### BOYNE CITY PLANNING COMMISSION

Monday May 20, 2019 5:00 p.m.  
Boyne City Hall

**Subject:** Lofts on Lake Street Development Plan Review

To: City Manager and Department Heads  
From: Scott McPherson Planning Director  
Date: May 7, 2019  
Subject: Dept Head Review Lofts on Lake Street

**PROPOSED GRADING & DRAINAGE PLAN**  
 BC3 Ventures, LLC Property  
 Boyne City Site Plan Submittal 06 May 2019  
 Part of SECTION 35, T33N, R6W  
 BOYNE CITY, CHARLEVOIX COUNTY, MI

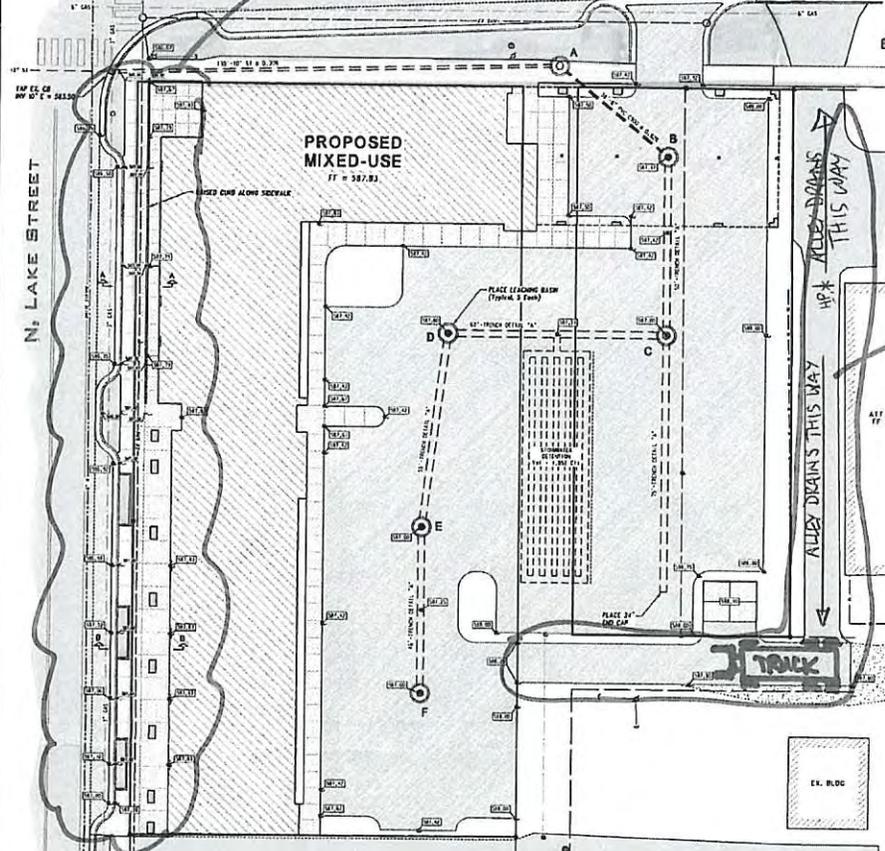
- ① Drainage of the existing + proposed alley?
- ② Sidewalk along N. Lake Street to be maintained by the owner including any portions in public ROW due to street scape impediments. Our machine would be difficult to navigate through there and we have no place to pile snow.
- ③ Dumpster enclosure location does not easily facilitate Front-End Loader collection requiring hard 90° turn into enclosure + no room to back-up. Suggest 45° angle or relocate elsewhere on-site.

*No Place to blow snow into windows with trackless*

*how is this area done?*
